| Problem Name	DS-1280ZJ-XS & DS-1280ZJ-S are not compatible with DS-2CD20XX bullet

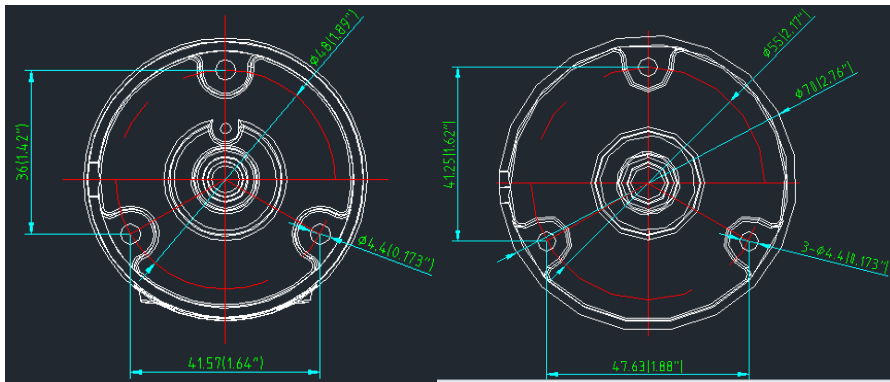
Problem Description Issue A	1.DS-2CD20XX, include R0/R2/R6 platform, have two kind of base structure, the difference is diameter, the diameter of old one is 48mm, the newer one is 55mm. Showed as below:

48mm base structure 55mm base structure

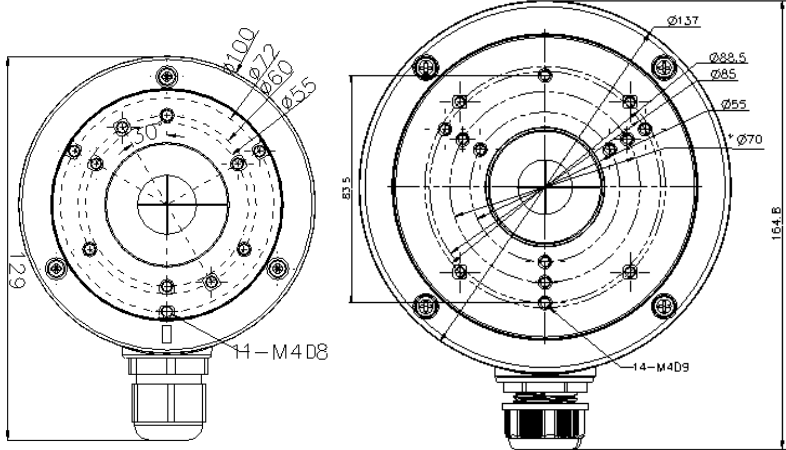
3. Base on two points above, if DS-2CD20XX with 48mm base structure can't be compatible with DS-1280ZJ-XS or DS-1280ZJ-S. DS-2CD20XX with 55mm base structure is compatible with 1280ZJ-XS and DS-1280ZJ-S, Show as below

4. The switch time in factory for 55mm and 48mm base structure is 9^{th} September 2015. DS-2CD20XX produced before 9^{th} September, the base

structure is 48mm one. DS-2CD20XX produced after 9[th] September, the base structure is 55mm one. 5. Conclusion: DS-2CD20XX produced before 9[th] September, there is no junction box now. DS-2CD20XX produced after 9[th] September, we can use junction box DS-1280ZJ-S or DS-1280ZJ-XS.
Problem Description Issue B	1. DS-2CD20XX with PoE on the cable can't use the junction box DS-1280ZJ-XS, because the PoE modular is too large to hide in DS-1280ZJ-XS. Must use DS-1280ZJ-S. 2. DS-2CD20XX without PoE on cable can use DS-1280ZJ-XS, DS-1280ZJ-S can be also used, but DS-1280ZJ-S is much larger than DS-1280ZJ-XS, so using DS-1280ZJ-XS looks better. 3. How to judge: DS-2CD20XX which support PoE and SD card, there is PoE modular in cable. DS-2CDD20XX which doesn't support SD care, there is no PoE modular in cable.
Conclusion base on Issue A & B	see table below
